3.6 ESD Commitments - Ratings

3.7 Facades

4.0 Design Development

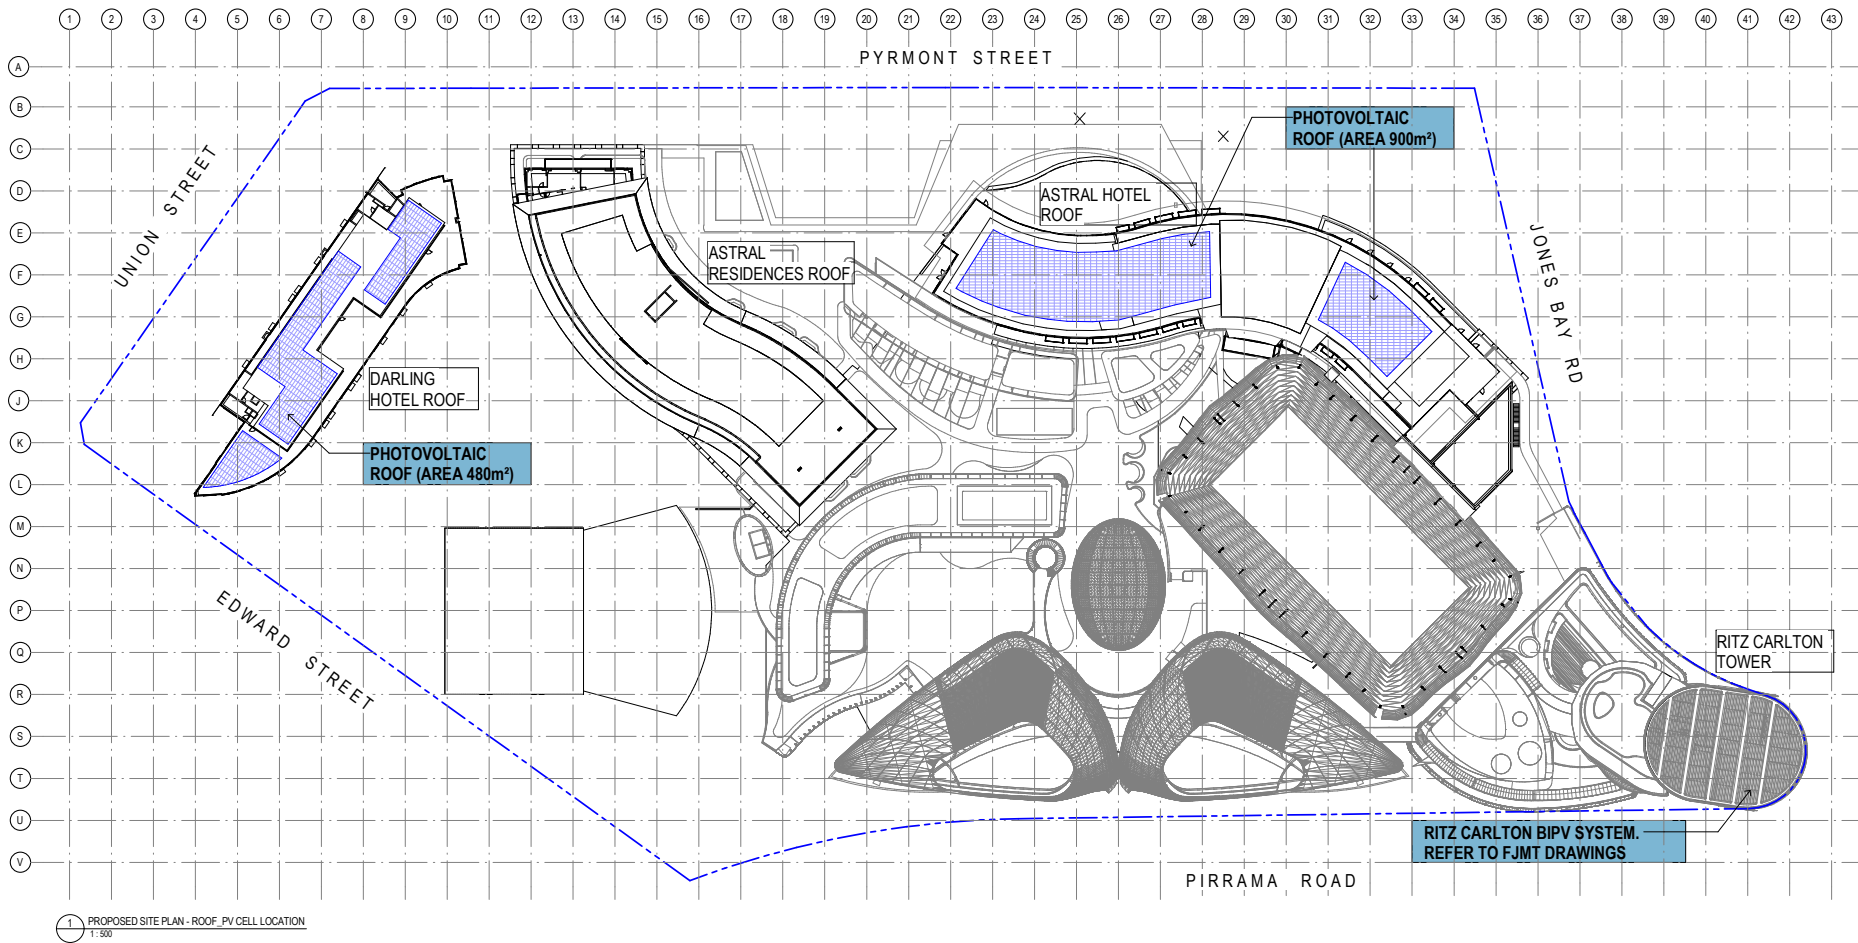
The main plan set are lacking in several aspects of documentation notation:

- No NatHERS stamping on main plan set;
- No NatHERS thermal comfort summary block;
- No BASIX Specification Block summarising BASIX commitments;
- No reference to size of solar system proposed to be put on MUEF roof. The BASIX Certificate (page 29) states '165 kilowatt peak'. Can this sized system actually be located on the roof? Where else is solar panels proposed? Will they be in shade from the tower? The plans need to state the system size as it is a BASIX commitment.

Updated plan set with Stamps and commitments are provided as an appendices to this document.

Building integrated photovoltaics are provided on the fixed shading louvre through specific locations on the tower facade. Supplementary information the BIPV can be found in the subsequent section 3.7 Facades, Facade Building Integrated Photovoltaics (BIPV). Site wide PV locations can be found on drawing **AS1500 PROPOSED SITE PLAN PV CELL** (shown below)

AF8300 Typical Tower Facade Details

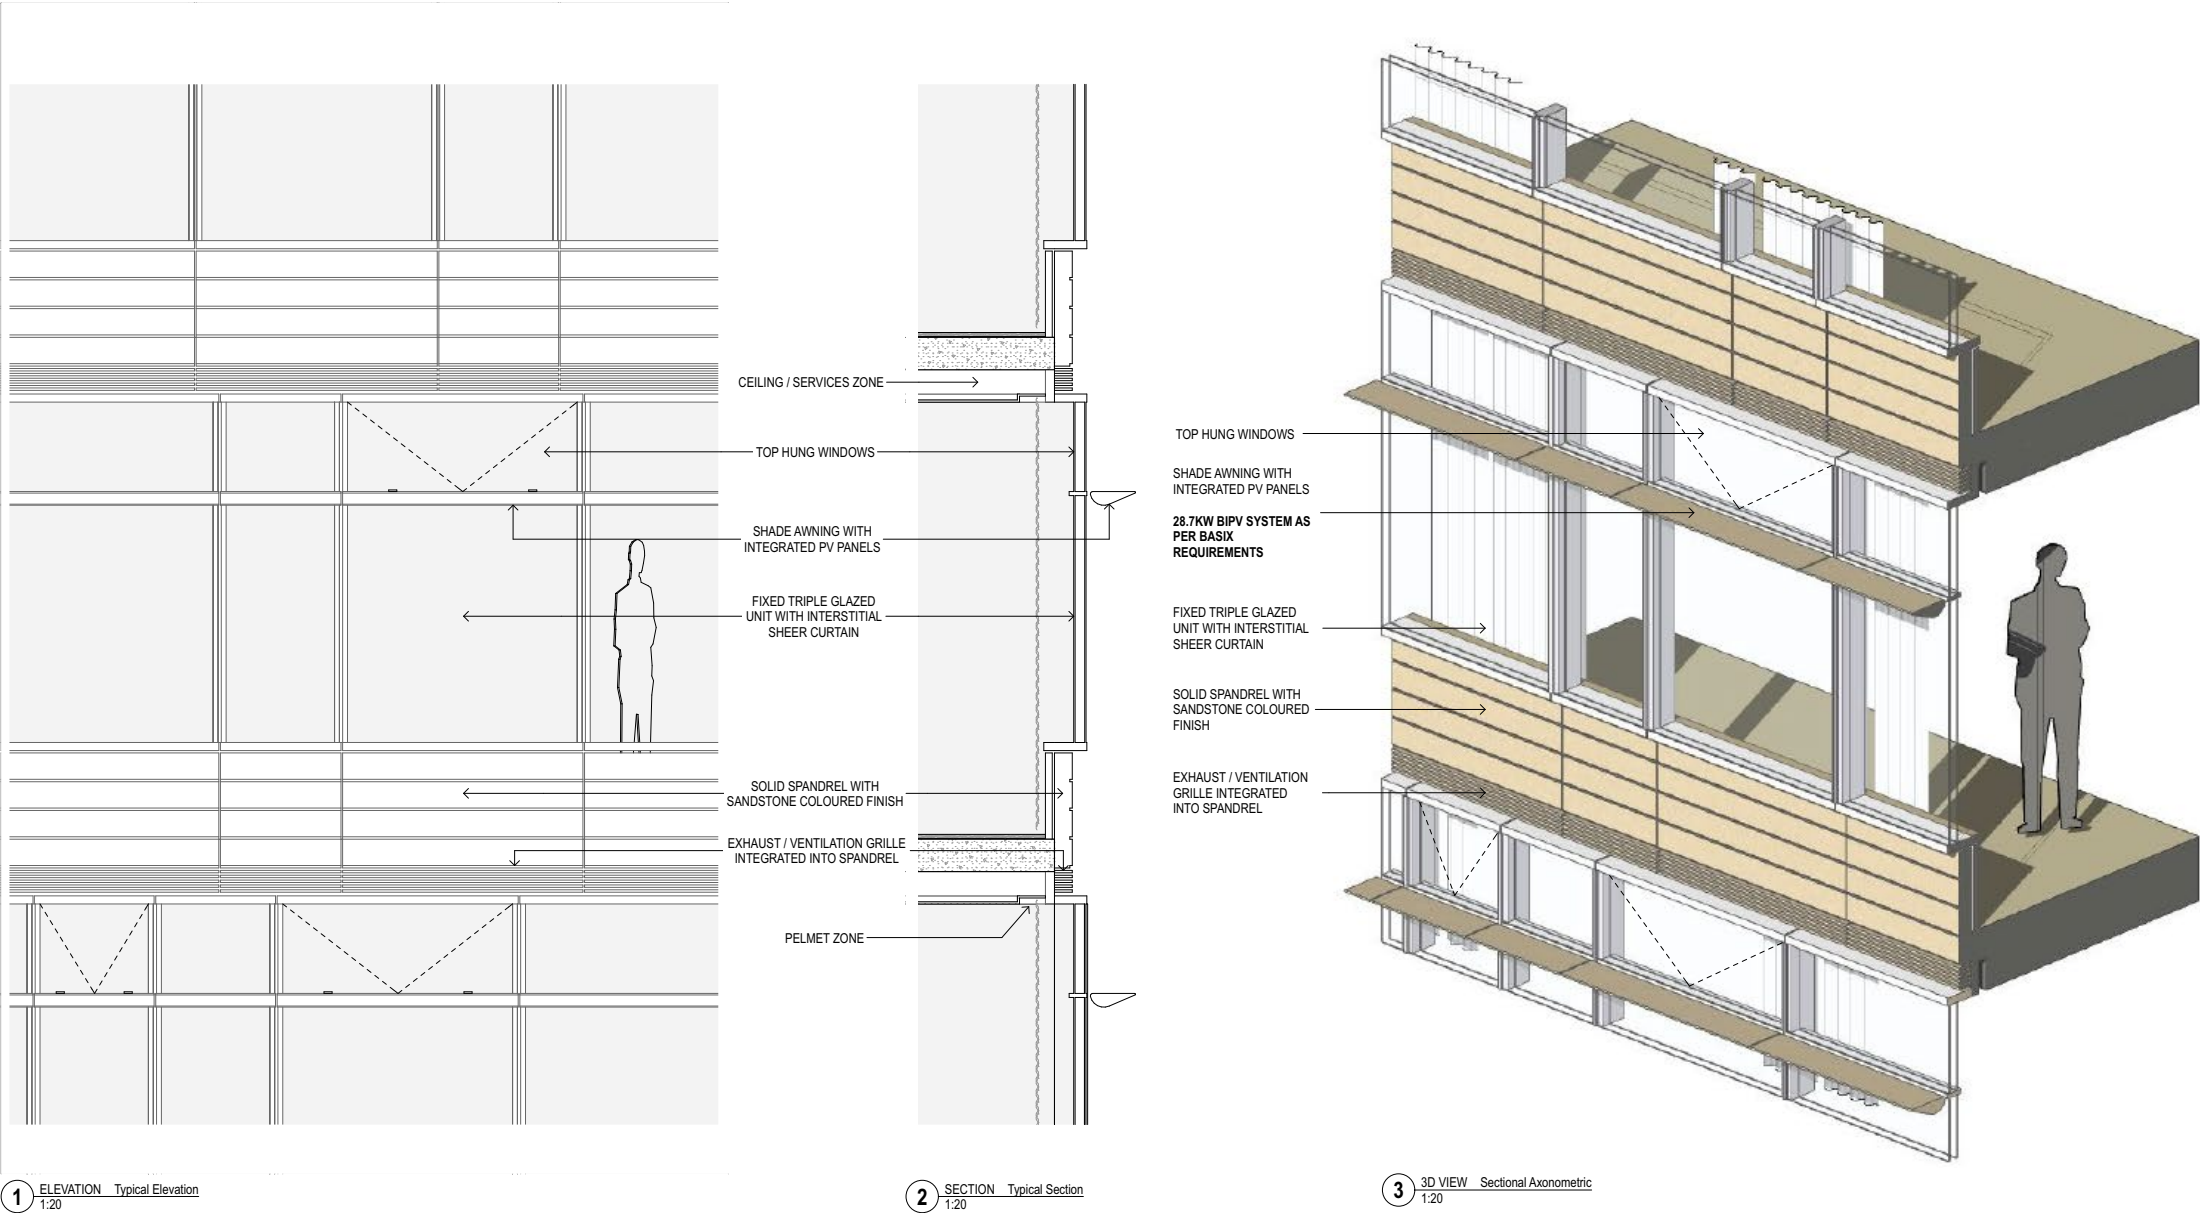
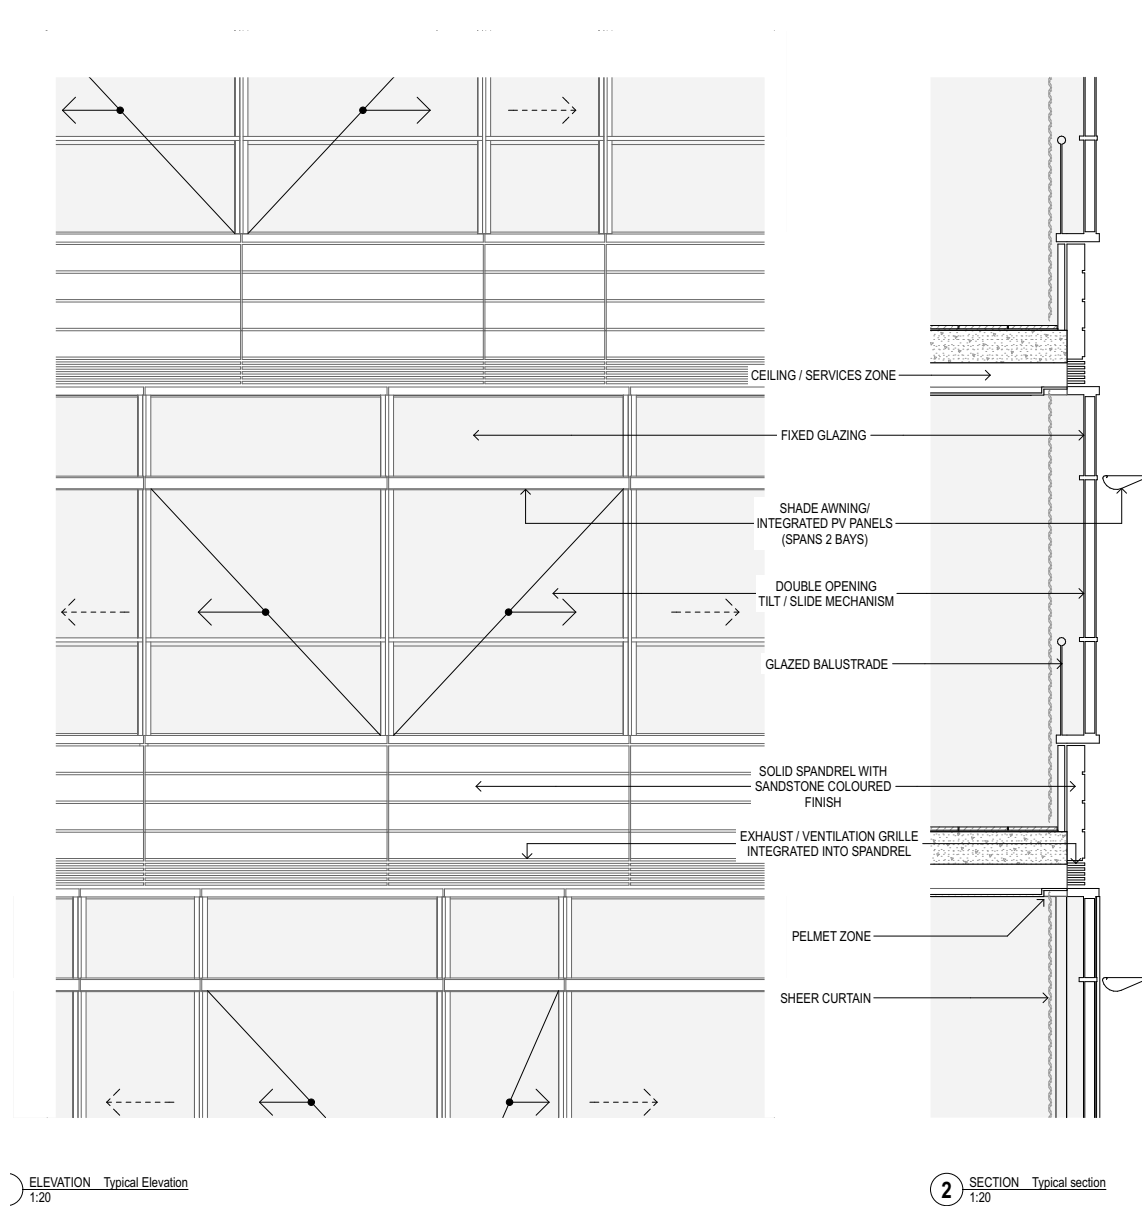
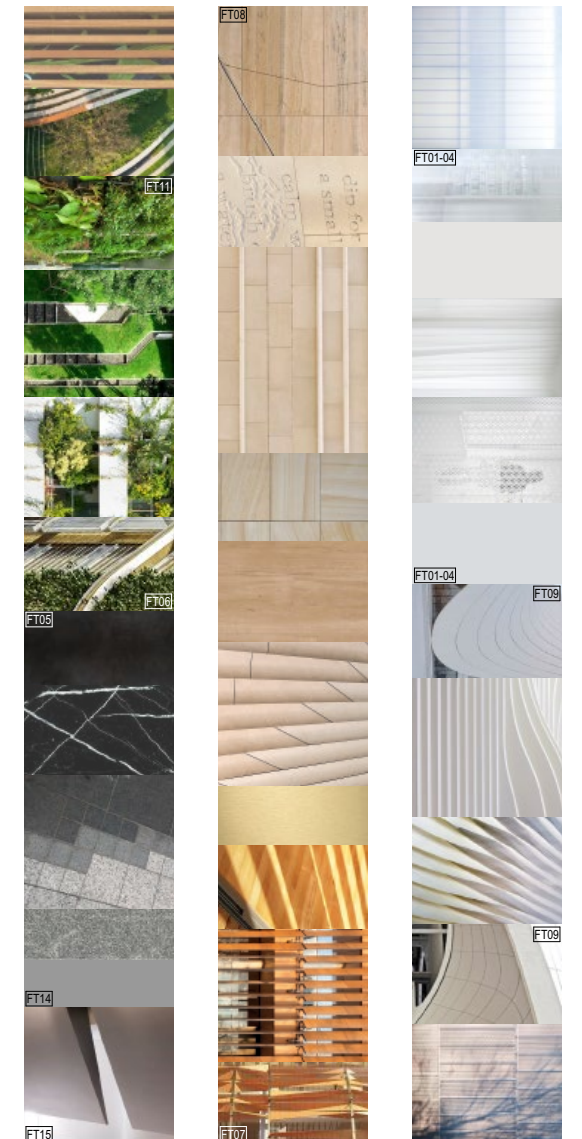
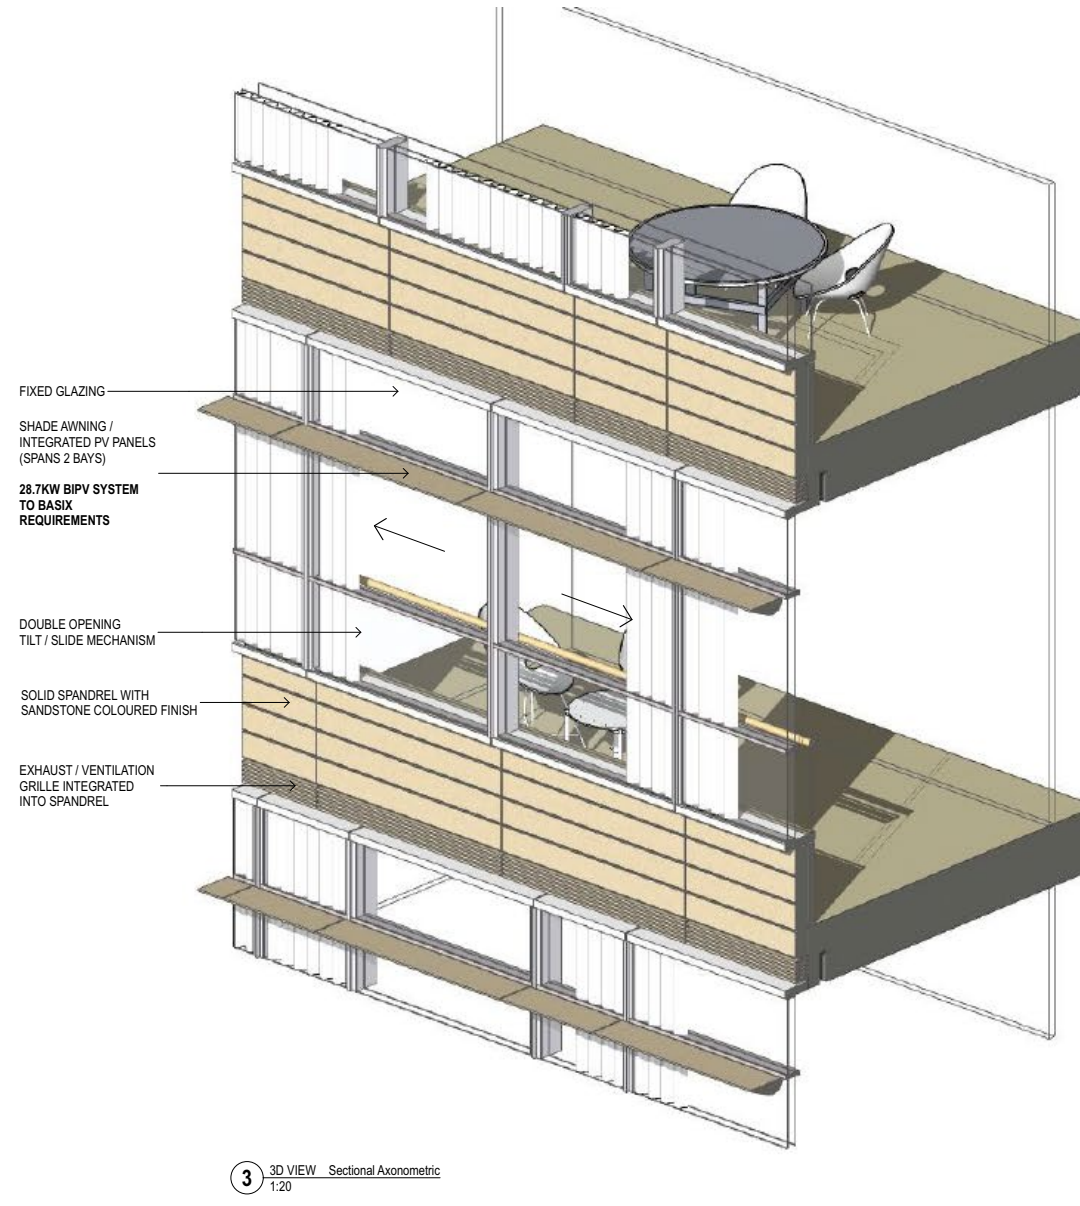
Confirm what measures will be employed to ensure the quality/appearance of the proposed tower glazing, and other proposed material, will be maintained throughout the detailed design development of the project.

The Architectural Design Statement as included in the submission for MP08_0098 MOD 13 included extensive and detailed description of the various facade systems as proposed. As part of the Response to Submissions, a number of new architectural drawings as related to the tower facade have been included in the Architectural Drawing Set, such that these drawings and the facade systems described therein become part of any approval.

The facade design will be developed in accordance with the intent of these drawings and the visualisations included in the Architectural Design Statement. Final system selections and materials will be reviewed and refined via a Visual Prototype as is industry standard for a large, high quality projects such as is proposed.

As the design is developed, we will continue to refine all the performance attributes and compile reference component/assembly parts. These will be incorporated in the construction documents (drawings, specifications and reference samples) and will therefore be the basis for assessing/ demonstrating compliance of the constructed product with the design intent.

Facade Operability - Typical Residential Level 30-38

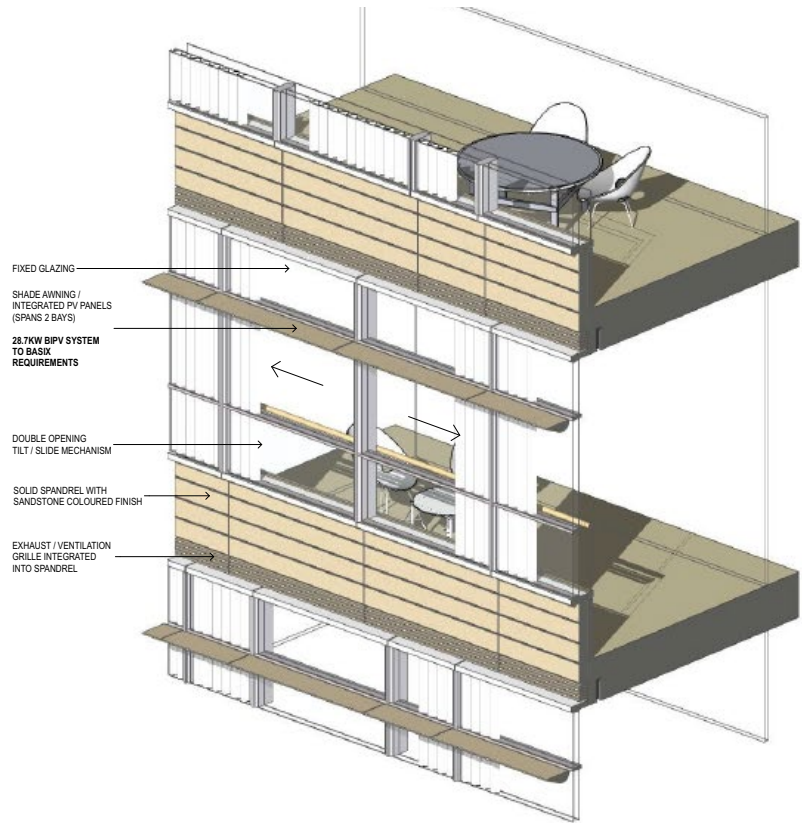
Confirm the location and design of operable windows to apartments and winter gardens within the tower. Update the perspective images of the tower where any necessary revision to the design of the glazing has a material impact on the appearance of the building.

The operable elements of the façade are shown on the drawings. There are two types; top hung operable windows and sliding wintergarden wall panels.

The top hung windows are conventional windows that have a separate frame within the grid of the curtain wall panels. Externally, as a consequence of the flush glazing (structural silicone) proposed, their presence will be largely veiled by the reflectivity of the surface.

The sliding panels are proposed to be on a 'tilt-and-slide' mechanism which will deliver the flush appearance of the remainder of the façade. The framing, will again be veiled by the flush glazing.

Typical Tower Facade Detail - highlighting spandrel grille for attenuated ducted ventilation and trickle vents

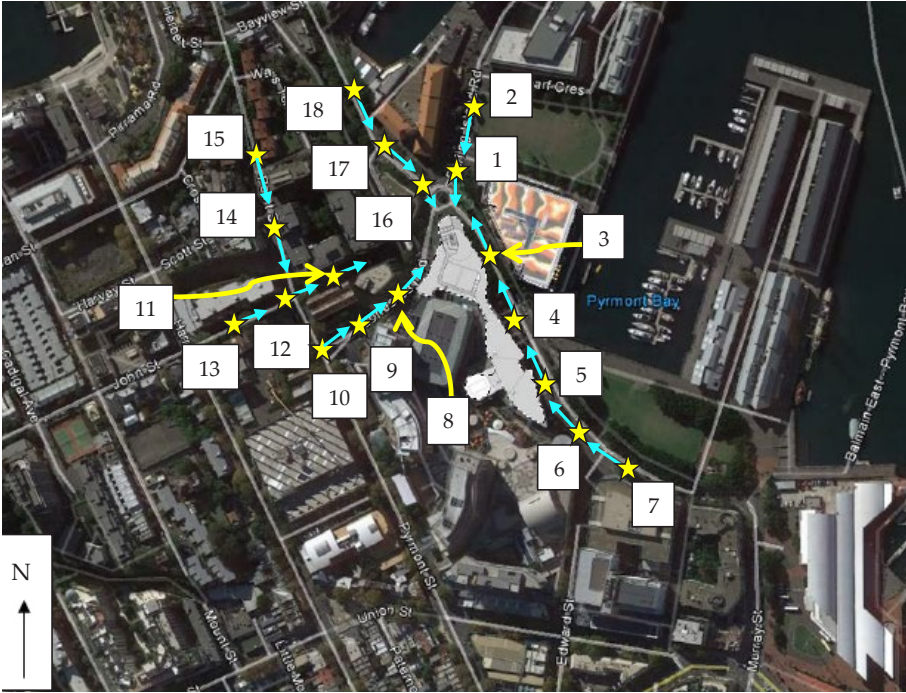
The Noise Impact Assessment states that all residential windows will need to remain closed with mechanical ventilation relied upon to meet required internal noise levels. This solution does not comply with Objective 4B-1 in the ADG requiring all habitable rooms to be naturally ventilated.

The apartments have been designed for outside air compliance via natural ventilation under the requirements of the NCC and ADG through a combination of ducted façade louvers and trickle vents in the spandrel which will both include appropriate acoustic treatment in the event of excessive external noise levels.

As noted on the architectural drawings and as noted in the mechanical report, the spandrel panels within the facade allow provision for grilles to provide for such a performance pathway.
